**Tree Inventory,
Assessment, and
Protection Report**

**14335 La Rinconada Drive
Los Gatos, CA 95032**

**November 6, 2023
Revised December 5, 2024**

Monarch Consulting Arborists

Appendix A: Tree Inventory Map and Proposed Grading and Drainage Plan

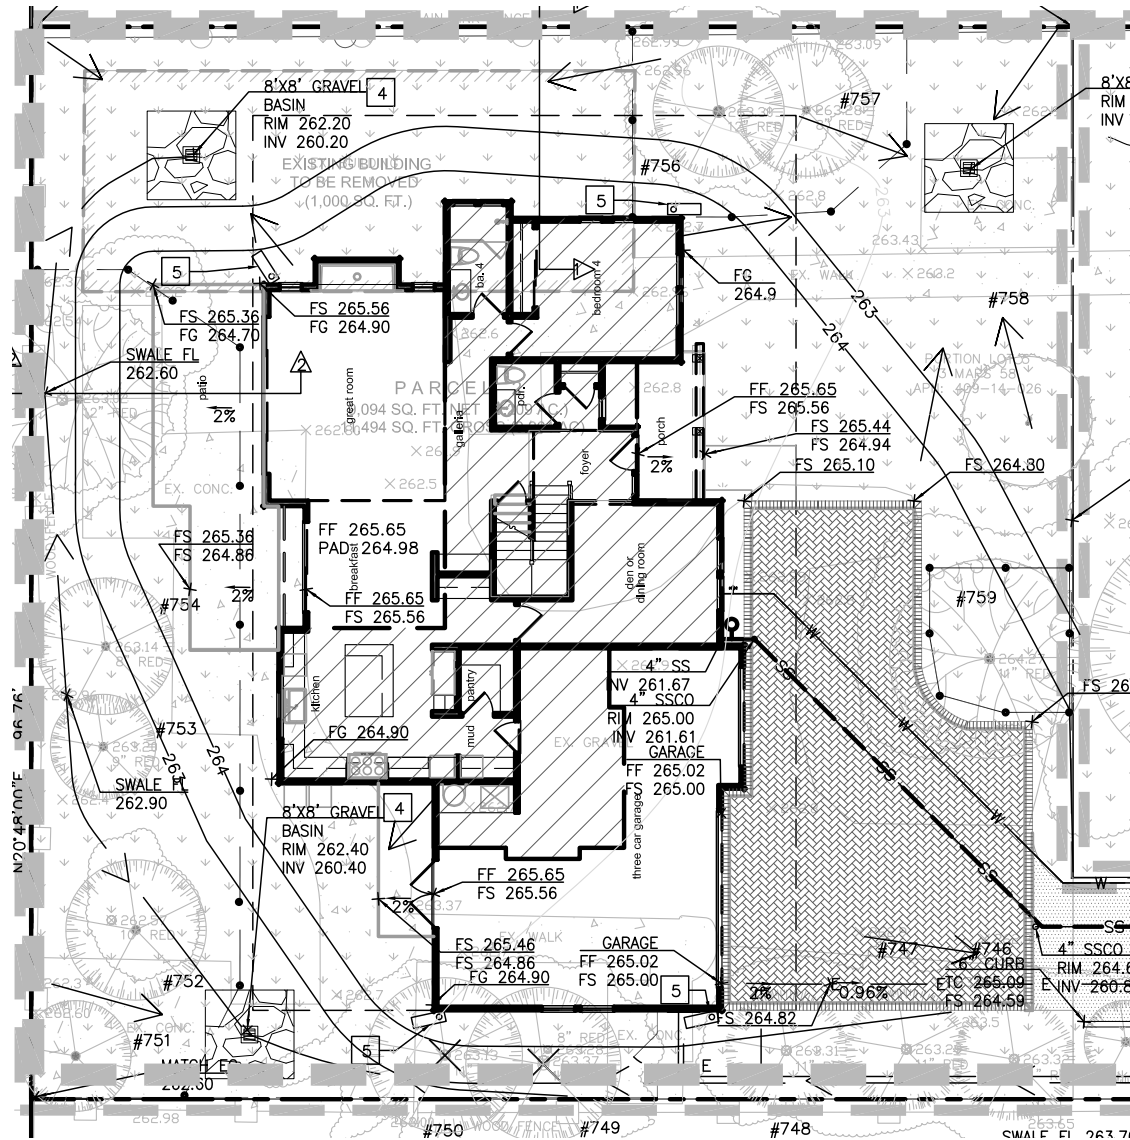
Parcel 2: Parcel 2 has several trees around the perimeter and only one (#759) has protection fence around it indicated on the plans. The remaining trees to be retained will also require fence and no grading within their calculated TPZs.

- Crape myrtle #758 tree protection fence should be placed at least five feet and more if possible.
- It may be possible to save some other trees but the way the C1 sheet is drawn at this time it appears there is drainage and grading requirements around the exterior which would compromise most of the trees. Altering this plan if possible could save some trees.

5. Place all the tree protection fence locations and guidelines on the plans including the grading, drainage, and utility plans. Alternatively create a separate plan sheet that includes all three protection measures labeled “T-1 Tree Protection Plan.”
